Office Action Summary

10/578,815

DETAILED ACTION

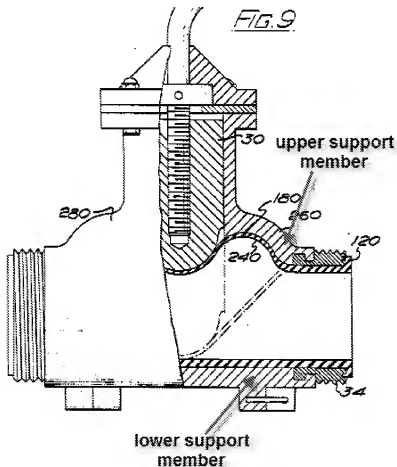
Regarding Claim 4, Summerfield discloses said housing 260, 280 is formed by an upper support member (see labeled Fig. 9 below) having a lower surface which engages an upper surface of said region of the valve body 200, and a lower support member (see labeled Fig. 9 below) having an upper surface which engages a lower surface of said region of the valve body 200, said upper and lower surfaces of said support members being of complementary shape to the respective upper and lower surfaces of the said region.

Regarding Claim 5, Summerfield discloses said support members define between each other a through opening through which said valve body extends (Fig. 9).

Regarding Claim 6, Summerfield discloses the region of the valve body 200 in which the seating area is defined has an upper wall and a lower wall, the upper wall being flexible and forming the diaphragm 180, and the lower surface 200 being rigid and its inner surface forming the valve seat (Fig. 9).

Regarding Claim 12, Summerfield discloses said wings 240 (Fig. 5) extend longitudinally along the valve body 200 and taper laterally towards said valve body 200 towards each end thereof so as to have a maximum width in the region of the valve seat (plunger area between wings 240 being wider than each wing, better seen in Fig. 9).

Regarding Claim 17, Summerfield discloses said operating means 30 is mechanically coupled to said diaphragm 180 such that upon movement of the operating means 30 towards the valve seat, the diaphragm 180 is pressed by the operating means 30 against said valve seat (Fig. 9) and upon movement of the operating means 30 away from the valve seat.
